NONCONFORMANCE REPORT

2. DRAWING/PART NO. 7220-M-92-29	REV. 3	7. PROJECT NO. 7220	12. REPORTED BY <i>Don Hendricks</i>	DATE 4-8-76
3. ITEM DESCRIPTION Polar Crane LH-51	8. ITEM LOCATION RR Siding	13. VALIDATED BY <i>Flannolly</i>	DATE 4-8-76	
4. SERIAL NUMBER CN-25088	9. STARTUP SYSTEM NO. N/A	15. REPLACEMENT PART NO. N/A	REV.	
5. PURCHASE ORDER NO. M-92	10. QC FIELD INSPECTION PLAN NO. N/A	16. REPLACEMENT SERIAL NO. N/A		
6. CONTRACTOR/LOCATION Harnischfeger, Milwaukee, Wisconsin	11. ASME CODE ITEM ☐ YES ☒ NO	17. SOURCE Vendor		
18. ROUTING INSTRUCTIONS: ☒ ROUTE TO FIELD ENGINEERING ☐ ROUTE TO MATERIAL SUPERVISOR

Job 7220 Midland Project
Reactor Building Crane
M-92-(0)-1

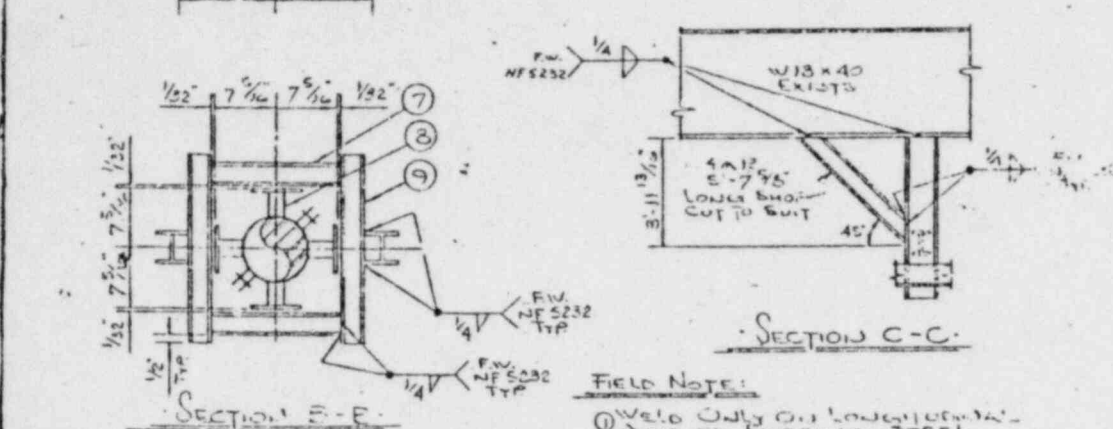
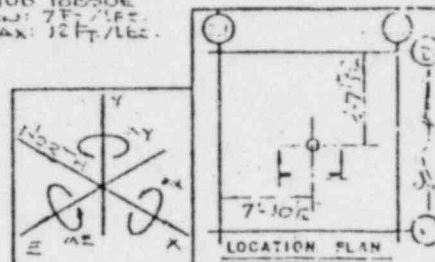
B. Contrary to the above, pipe hanger assembly part item 2 listed in sketch 1-619-7-25, Rev. 1 calls for one 6" I beam @ 12# / ft.; one 6" B beam @ 12# / ft. was delivered. The American Institute of Steel Construction does not list I beams at 12# / ft. The status of this beam is indeterminate - See exhibit A.

A) The material supervisor is to contact the vendor and obtain a corrected packing list showing the drawing revisions to which these hangers were fabricated.

ELEVATION AT 'D' LINE

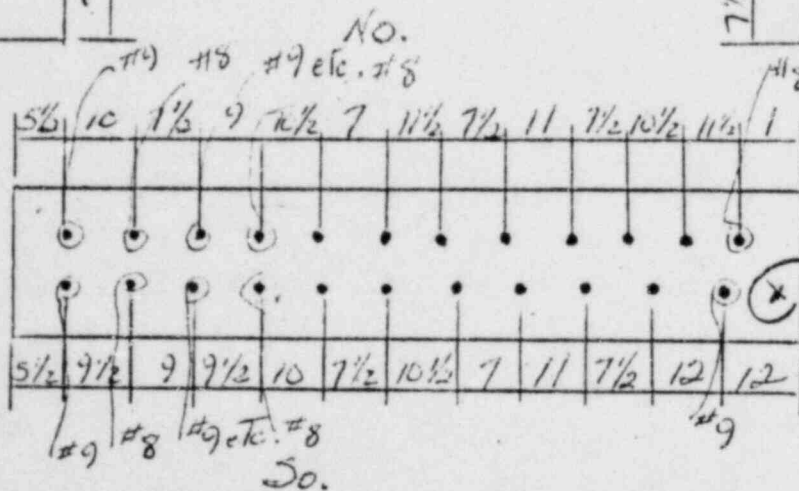
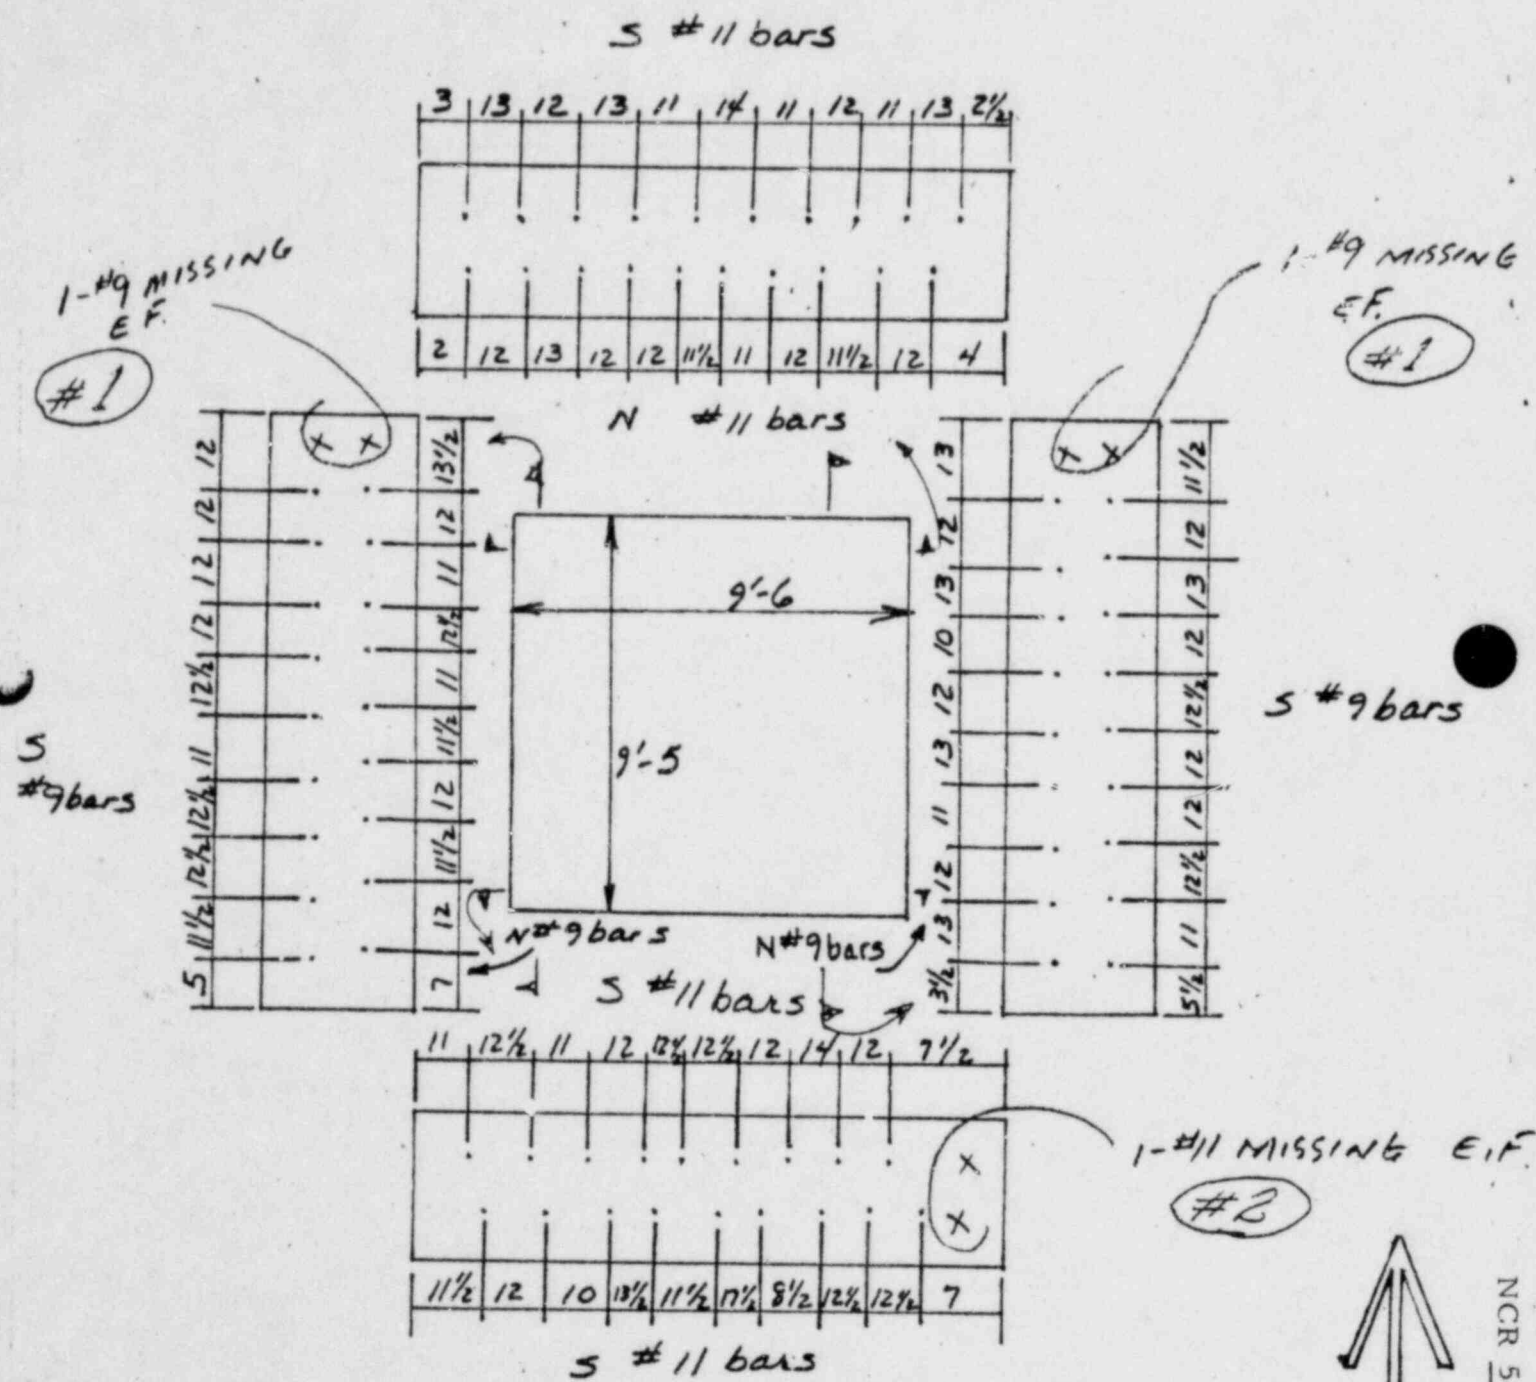
148 MISSING
#5

ELEVATION AT 'F' LINE

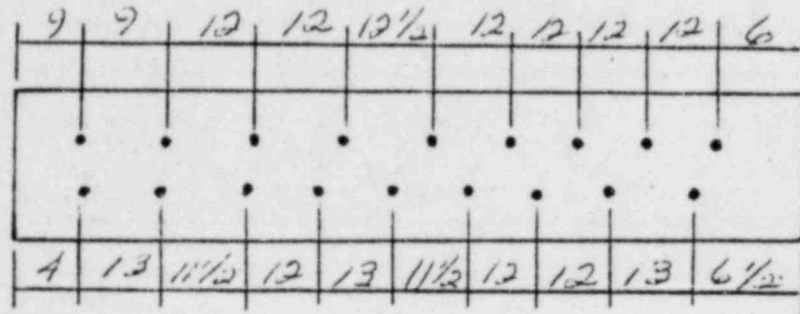
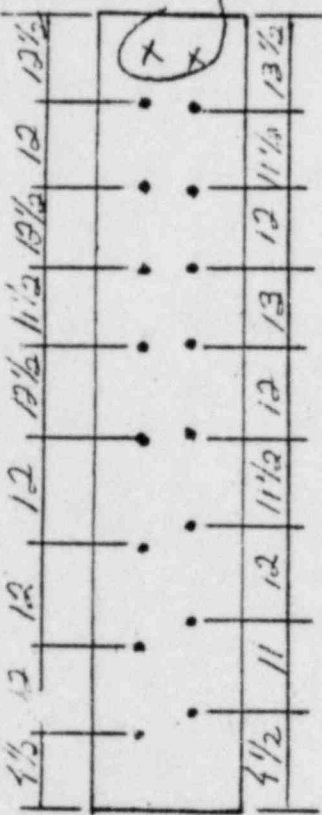
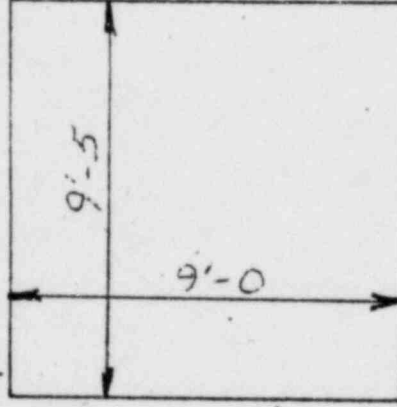
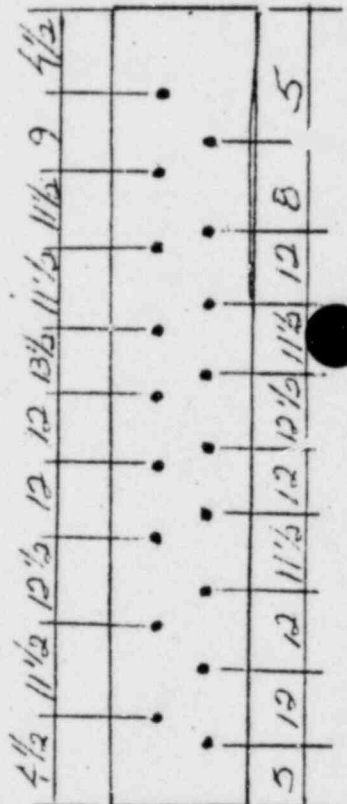
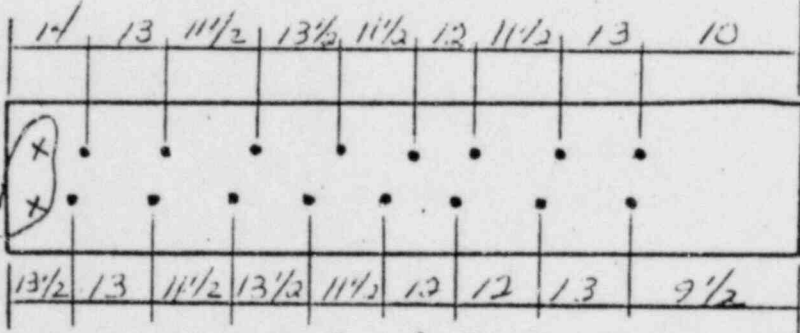
#3
1-#9 MISSING
EF

1-#11 MISSING
EF

4. REF. DWG. OR SPEC. 7220-C-219 REV. 8 5. TITLE Addt'l rebar in header above door opening at G/6.6

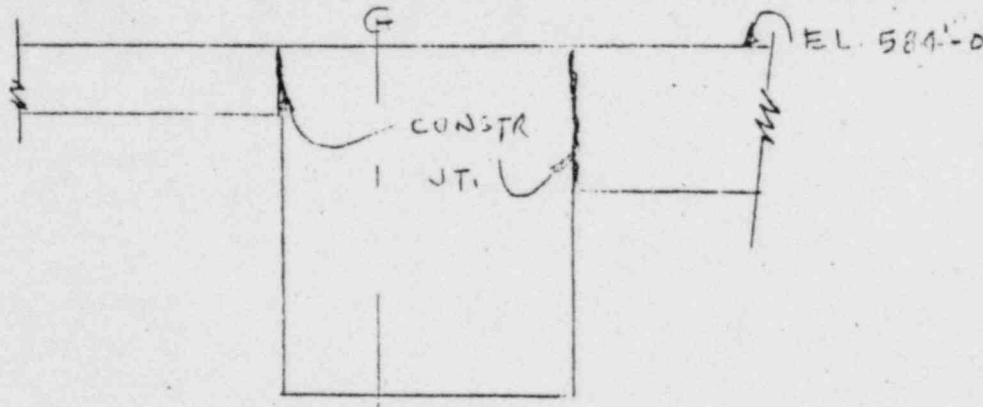
7. EXISTING CONDITION: Sections F & G of the referenced drawing show an additional 4-#8 horizontal bars and 6-#5 cap bars @ 12" below an additional horizontal construction joint for the door header at G/6.6.

Revise sections F and G of the referenced drawing to:

- Delete the additional 4-#8 horiz. bars and 6-#5 cap bars.
- Show the following as-built construction joint arrangement:

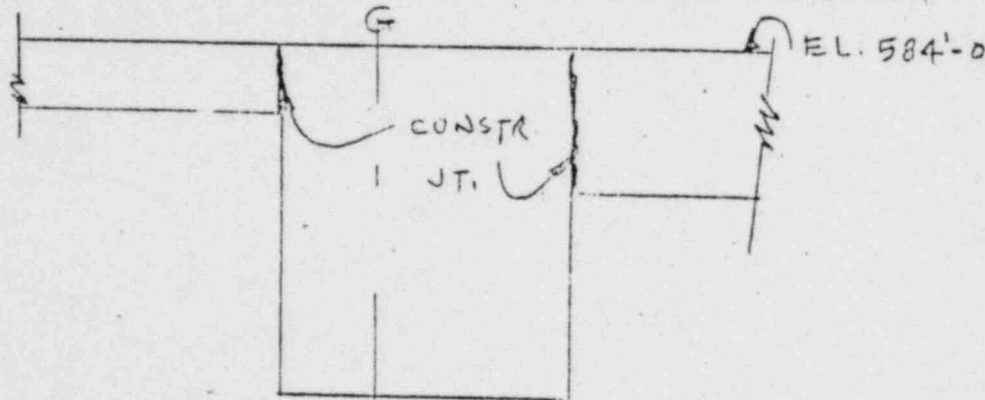
Sections F & G of the referenced drawing show an additional 4-#8 horizontal bars and 6-#5 cap bars @ 12" below an additional horizontal construction joint for the door header at G/6.6.

Revise sections F and G of the referenced drawing to:

- Delete the additional 4-#8 horiz. bars and 6-#5 cap bars.
- Show the following as-built construction joint arrangement:

ASME HANGER #16-HBC-134-H1

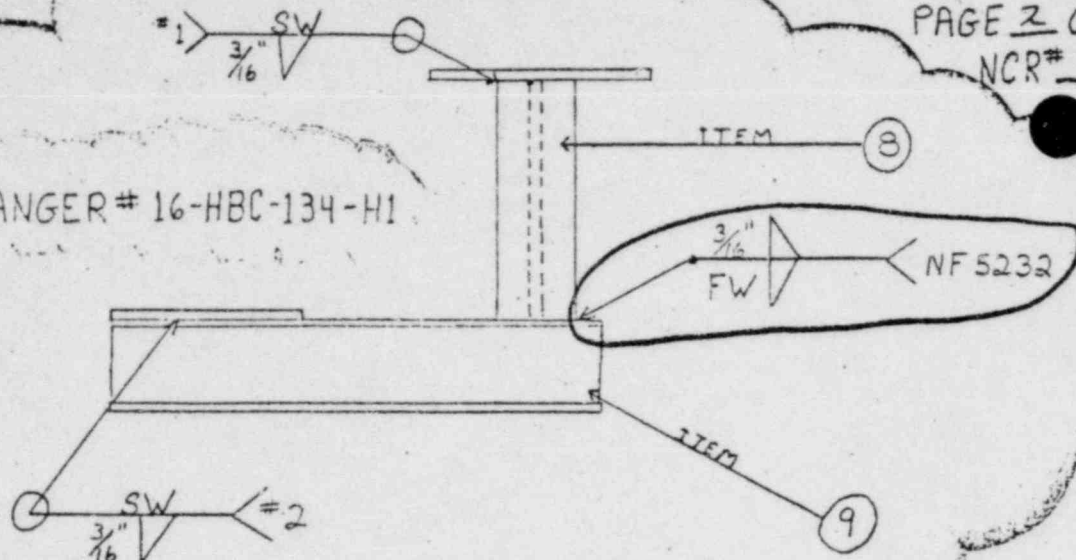
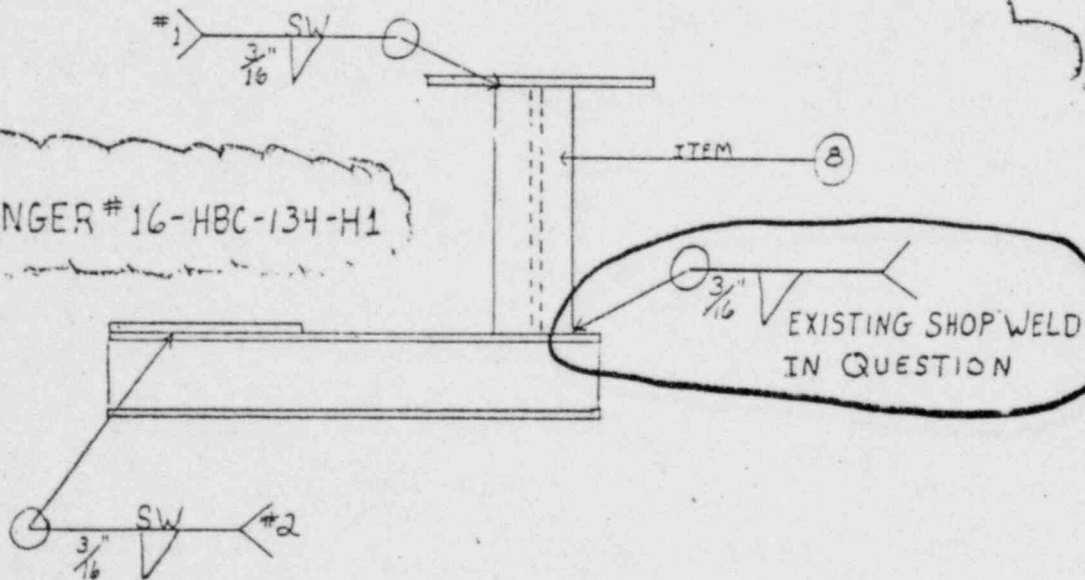
16. Nonconforming Condition: Grinnell Hanger Sketch (Drawing) 2-617-6-1 Rev. 2 for the referenced Hanger, requires the 3/16" Fillet Weld joining item 8 to item 9 to be a Field Weld across the flange of item 8 only. Contrary to the above design, a 3/16" Shop Fillet Weld has been made completely around the flanges and web of the item 8 to item 9 joint. "Q" Number 4.172 1 Hold Tag Applied Hold for disposition			24. Disposition Concurrence REWORK REJECT REPAIR USE AS IS A. J. Boon 1-24-76 PROJECT FIELD ENGINEER DATE A. J. Boon 1-24-76 PROJECT ENGINEER DATE A. J. Boon 1-24-76 PROJECT CONSTR QC ENGINEER DATE AUTHORIZED INSPECTOR DATE

17. Reported By Timothy Anderson 11-19-76		18. Validated By A. J. Boon 11/19/76		25. Disposition Res Its Based on approved drawing QAR SD-14 no further disposition is required. attached 1/24/77

21. Routing ☒ TO FIELD ENGINEERING ☐ TO OTHERS (SPECIFY)		22. ☒ Field Engineering Disposition ☐ FIELD ENGINEERING RECOMMENDED DISPOSITION TO PROJECT ENGINEERING THE ABOVE DESCRIBED 3/16" FILLET DOES NOT REPRESENT A NONCONFORMING CONDITION. REF: PROJECT ENGINEERS REPLY TO QUALITY AUDIT REPORT SD-14. A. J. Boon 1-24-77 A. P. 1-24-77

NCR 659
 DEPT. _____
 DRW'N DT CHK'D DM L. G. 75
 REV. EMH 3/17/75 CHK'D DMH
 REV. _____ CHK'D _____

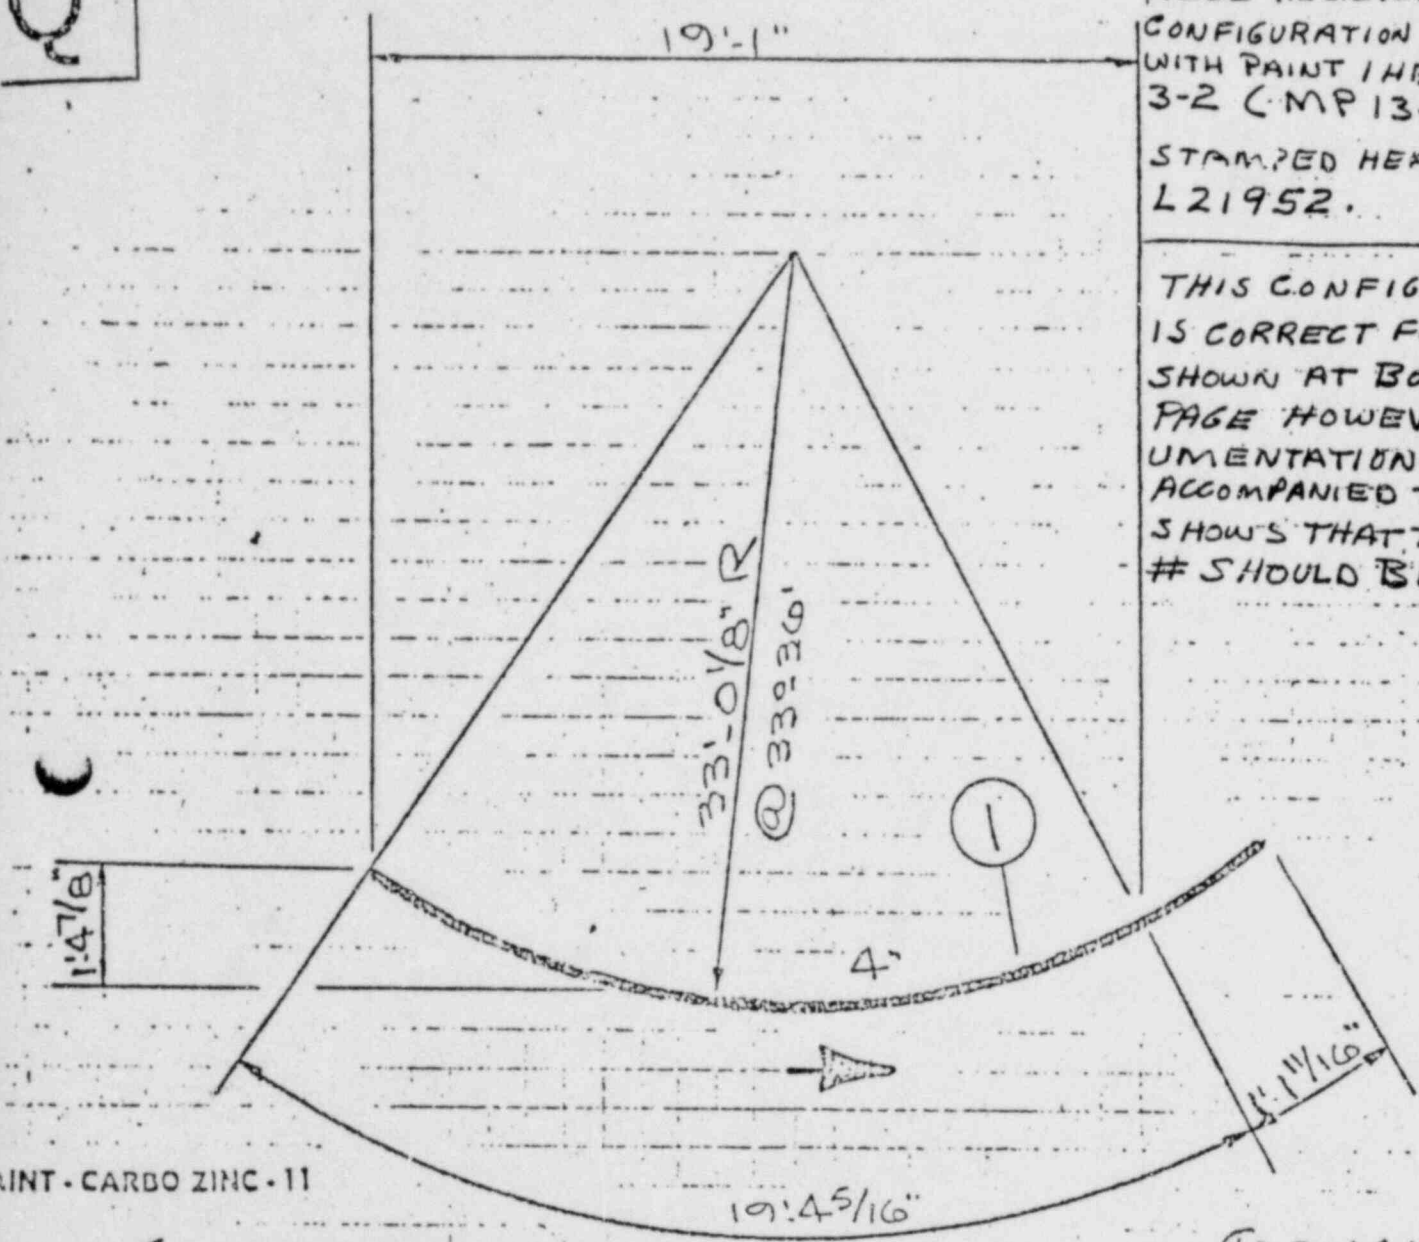
PIECE RECEIVED IN THIS
 CONFIGURATION IS MARKED
 WITH PAINT 1 HBC-303-5512-
 3-2 (MP 13-2)
 STAMPED HEAT CODE IS
 L21952.

THIS CONFIGURATION
 IS CORRECT FOR SPOOL #
 SHOWN AT BOTTOM OF
 PAGE HOWEVER DOC-
 UMENTATION WHICH
 ACCOMPANIED THIS SHEET
 SHOWS THAT THE HEAT
 # SHOULD BE L21942

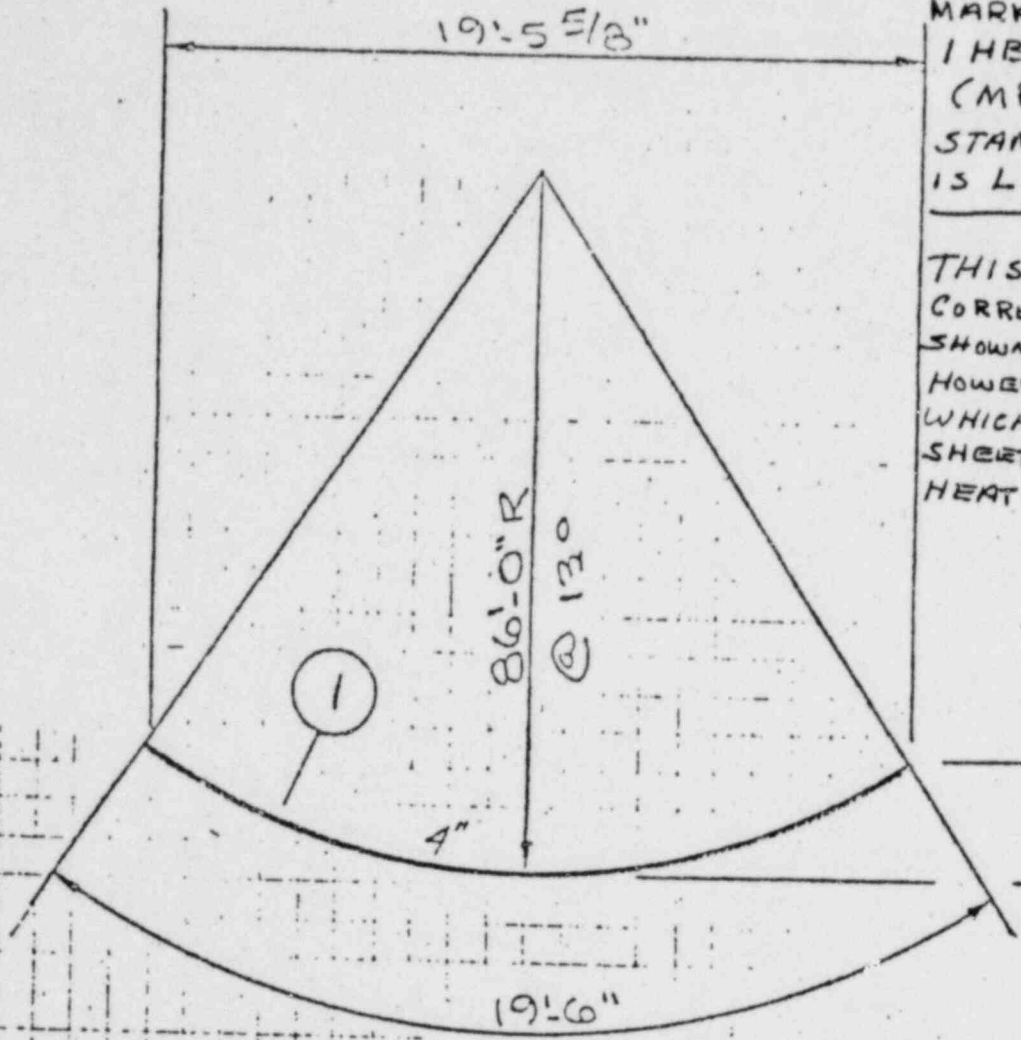
PIECE RECEIVED IN
THIS CONFIGURATION IS
MARKED WITH PAINT
1 HBC-303-S-512-3-3
(MP 13-3).
STAMPED HEAT CODE
IS L 21942.

SECTION B-B

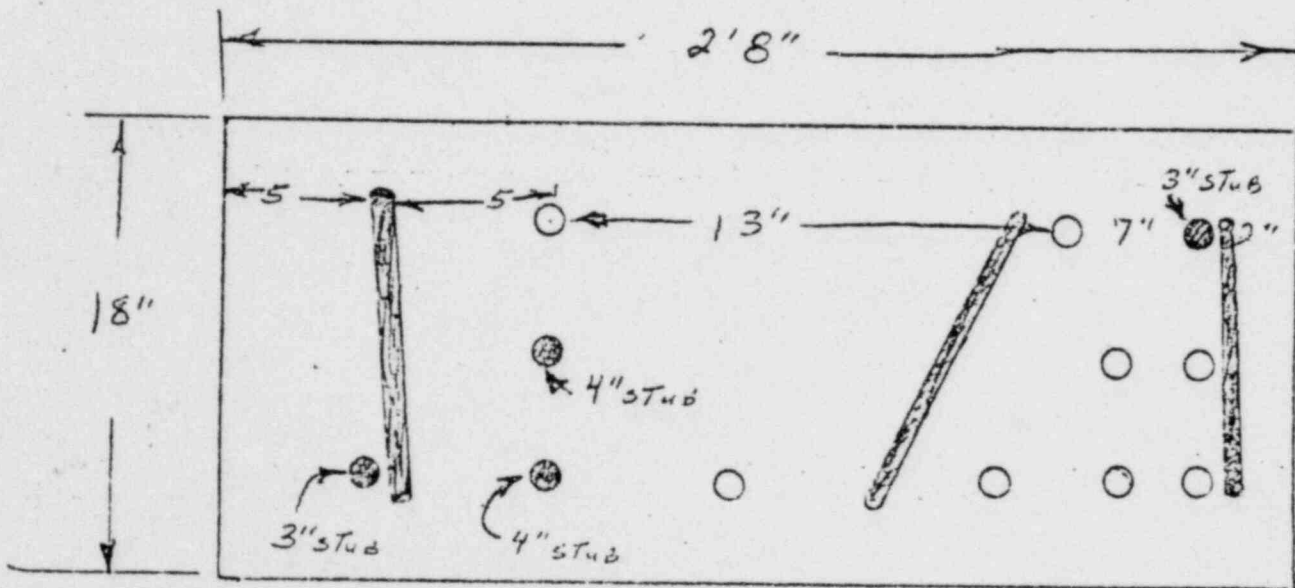
● BROKEN REBAR #6 NO SCALE
